UNSAFE STRUCTURES BOARD HEARING CASE RESUME

CASE NO.: 15-4614

BUILDING ADDRESS: 600 Biltmore Way

BILTMORE II CONDOMINIUM BUILDING FORTY-YEAR INSPECTION

PHOTO # 1: Vertical cracking on building wall located at balcony Unit #219

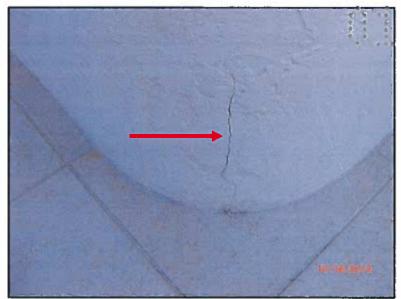
- 1. The building structure is generally in good condition.
- 2. The interior walls of balconies are in good condition overall. Minor cracking was observed on interior balcony wall and building wall (photo #1, photo #2 and photo #3) location.

The walls of the balcony slabs are typically in good condition, the inspected residential units' exhibit cracking at balconies. This is an indication of moisture intrusion into the block wall, with subsequent delamination of stucco. If left unabated, the stucco at the balcony block wall will eventually spall off, creating a falling debris and life safety hazard for residents and pedestrians below. We recommend the balcony walls be repaired where there are sign of cracking and

delamination. In addition, we also recommend that all balcony block walls be streeyed to document similar conditions.

PHOTO # 5: Concrete spalling at balcony ceiling at Unit #416

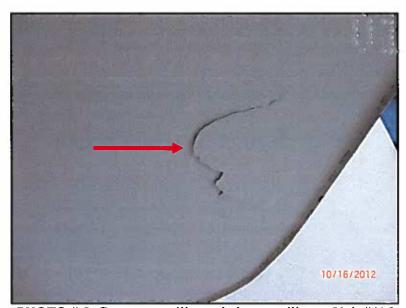
- 3. The balcony slabs are in fair condition. Spalled concrete with corroded reinforcing steel was noted on the balcony ceilings of Units 219 and 416 (photo #4 and photo #5).

Although the edges of the balcony slabs are typically in fair condition, some units exhibit cracking and concrete spalling at the slab edge and at the underside of slab above. This is an indication of moisture intrusion into the concrete, with subsequent corrosion of the reinforcing steel. If left unabated, the concrete at the edges of balconies will eventually spall off, creating a falling debris and life safety hazard for residents and pedestrians below. It's recommended that balcony edges be repaired where there are signs of cracking and concrete spalling. In addition, we also recommend that all balconies be surveyed to document similar conditions.

PHOTO # 7: Cracking/delaminated stucco on balcony slab edge at Unit #407

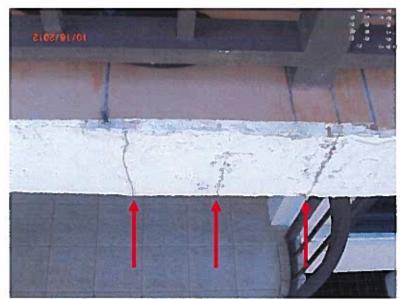
- 4. Minor stucco cracking at balcony railing connection to block wall of Unit 407 (photo #6).
- 5. We observed stuceo cracking along balcony's edge of Unit 407 (photo #7) and connection between block wall and building column of Unit 219 (photo #8).

PHOTO # 9: Delaminated/cracking stucco at exterior of Generator Room at roof area

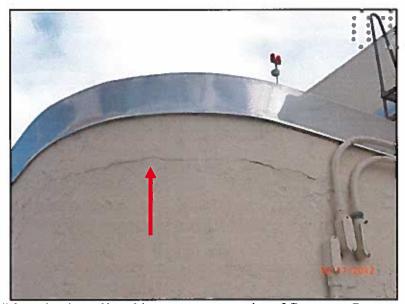
- 6. The roof edges of the Generator Room (photo #9) and East Elevator Machine Room (photo #10) at Roof Area have fine horizontal cracks which exhibit signs of water infiltration.

PHOTO # 12: Horizontal cracking at PH exterior wall

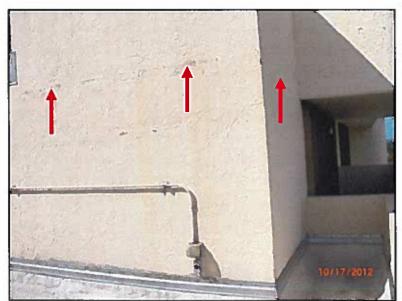
- 7. The interior block wall at the east side of the Elevator Machine Room at the Roof Area was observed with step cracking (photo #11).
- 8. The roof edge of the Penthouse exterior wall (photo #12) was noted with fine horizontal cracks which exhibit signs of water infiltration.

PHOTO # 15: slab cracking at column drop panel next to Parking Space No. 267

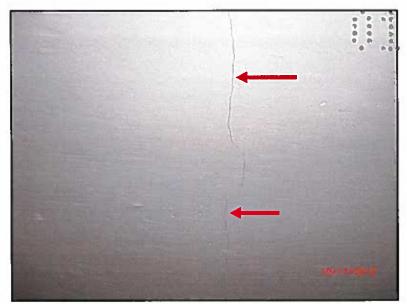
- 9. The interior block wall at the West Elevator Machine Room is not mortared properly at patched area (photo #13).
- 10. Hair Line cracking across column drop panel next to Parking Space No. 267 (photo #14 and photo #15).

PHOTO # 16: Unsealed wall, pipe penetration at Fire rated assembly (2hr fire rated assembly)

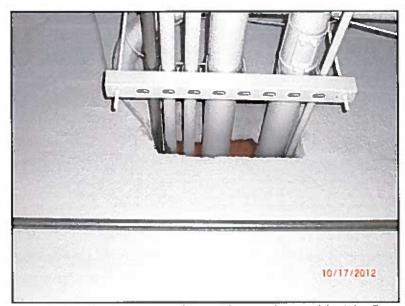
- 11. Unscaled wall pipe penetration at fire rated separation (2hr Fire rate assembly) (photo #16).
- 12. Hair line cracking on slab and beam was noted next to Parking Space No. 210 (photo #17 and photo #18).

PHOTO # 20: slab cracking at column drop panel between Parking Spaces 245 & 246

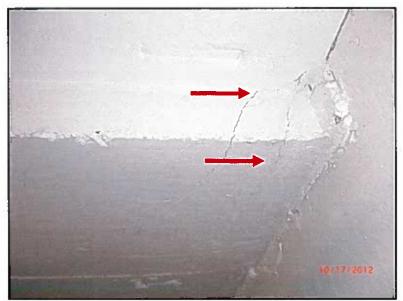
- 13. Hair line cracking across column drop panel between Parking Space No. 248 & 249 (photo #19).
- 14. Hair Line cracking at column drop panel corner between Parking Space No. 245 & 246 (photo #20).

PHOTO #23: cracking and water intrusion at underside of ramp in front of Parking Space 61

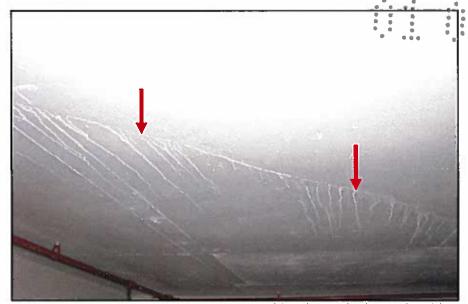
- 15. Trench drain drop ceiling opening over flows at opening between Parking Spaces No. 314 & 327 (photo #21 and photo #22).
- 16. Surface cracking and water intrusion was noted at underside of ramp on front of Parking Space No. 61 (photo #23).

PHOTO # 25: trench drain drop ceiling between Parking Spaces 52 & 61

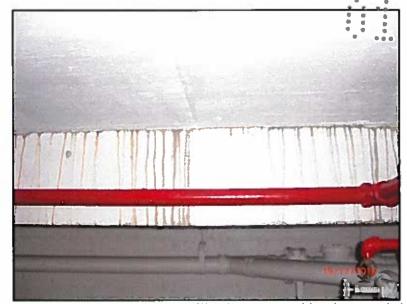
- 17. Trench drain drop ceiling opening over flows at opening between Parking Space No. 52 & 61 (photo #24 and photo #25).
- 18. The East end of the Parking Garage wall exhibits hair line cracking next to Parking Space No. 51 (photo #26).

PHOTO # 27: Unsealed wall, pipe penetration at Fire rated assembly (2hr fire rated assembly)

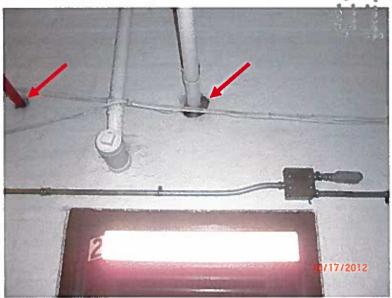
- 19. Unsealed wall pipe penetration at fire rated separation (2hr Fire rate assembly) above Fire Pump Room door (photo #27).
- 20. Hair Line Cracking on Overhang at West side (photo #28).

PHOTO # 30: cracking & blistering at underside of overhang edge

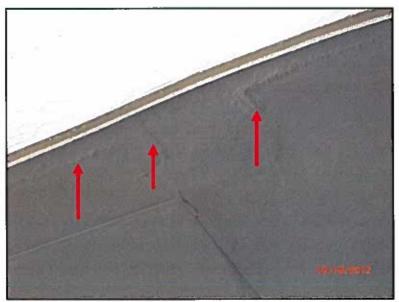
- 21. Hair Line Cracking and staining on balcony edge at Third level on north side (photo #29).
- 22. Blistering and underside cracking was observed at Overhang (photo #30).

PHOTO #31: stucco cracking at bottom of third floor balcony wall on East side

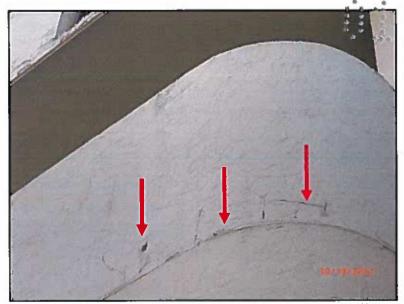
- 23. Cracking at bottom of balcony wall was noted (photo #31).
- 24. Crack along tiled pedestrian ramp east of main entrance was observed (photo #32).
- 25. Delaminated stucco and cracking at bottom of fourth floor balcony wall on east (photo #33).

PHOTO # 34: stucco cracking on building wall next to east stairs tower

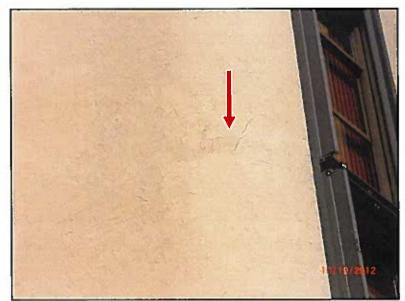
- 26. Surface cracks on building shear wall next to window shutter next to east stairs tower (photo #34).
- 27. Spider web cracking on exterior face at first balcony on East side (photo #35).

PHOTO # 36: ceiling separation at edge of South overhang

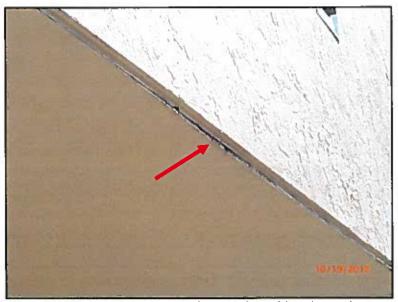
- 28. Ceiling panel separation at edge of South overhang (photo #36).
- 29. Stucco cracking on East side of building corner at Pool Deck Area (photo #37).
